**PCN# 20130909001
Datasheet update for 16DW Package Land Pattern
Information Only**

PCN Number:	20130909001			PCN Date:	09/17/2013
Title:	Change 16DW Package Land Pattern Data Sheet				
Customer Contact:	PCN Manager	Phone:	+1(214) 480-6037	Dept:	Quality Services
Change Type:					
☐	Assembly Site	☐	Assembly Process	☐	Assembly Materials
☐	Design	☒	Electrical Specification	☐	Mechanical Specification
☐	Test Site	☐	Packing/Shipping/Labeling	☐	Test Process
☐	Wafer Bump Site	☐	Wafer Bump Material	☐	Wafer Bump Process
☐	Wafer Fab Site	☐	Wafer Fab Materials	☐	Wafer Fab Process

DW (R-PDSO-G16)

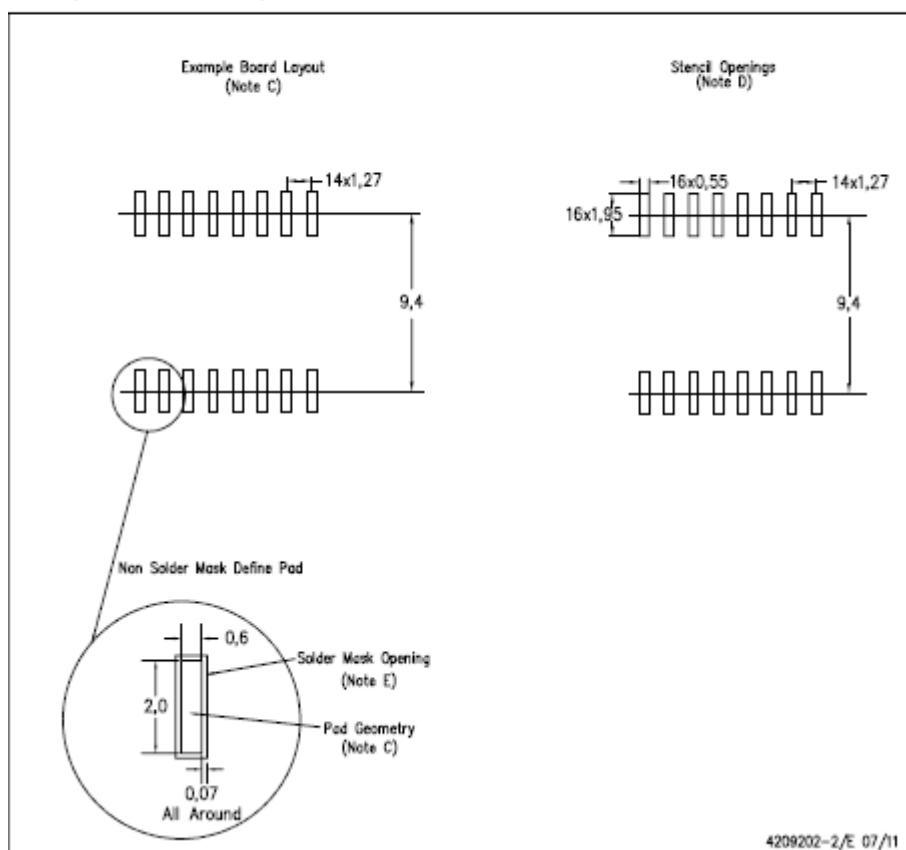
Change From:

LAND PATTERN DATA

DW0016B

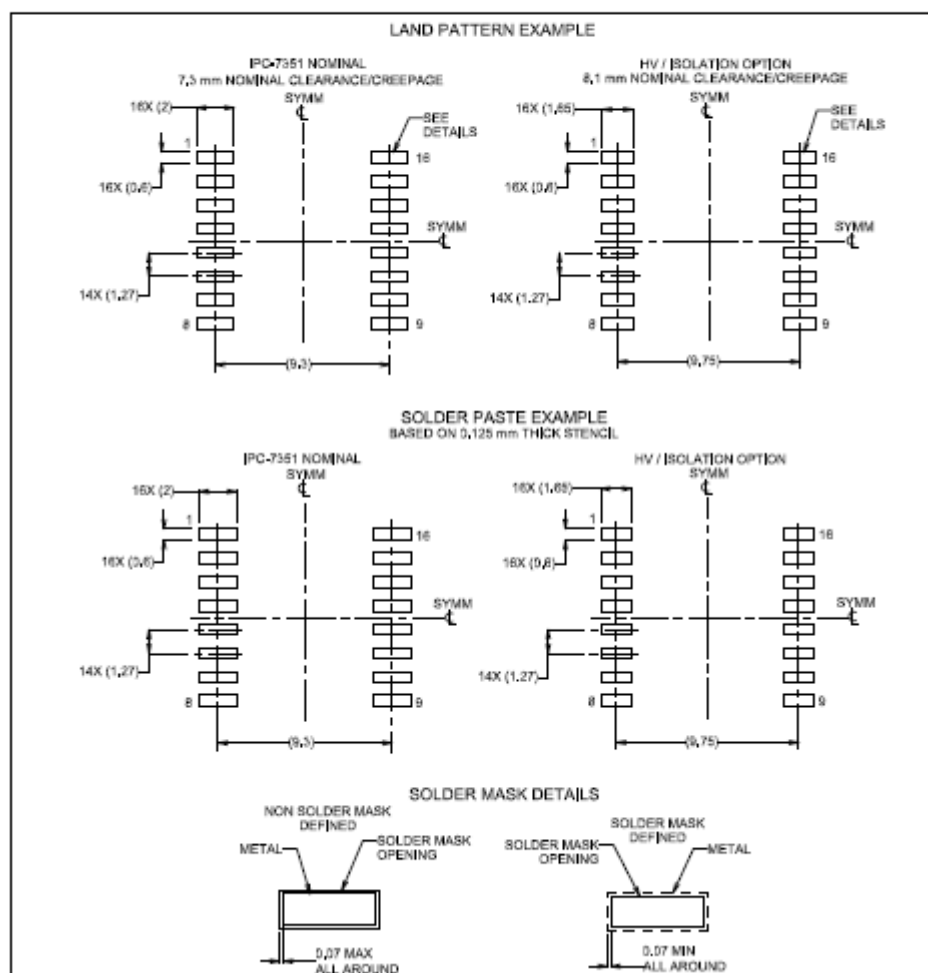
Change To:

EXAMPLE BOARD LAYOUT

To more accurately reflect device characteristics
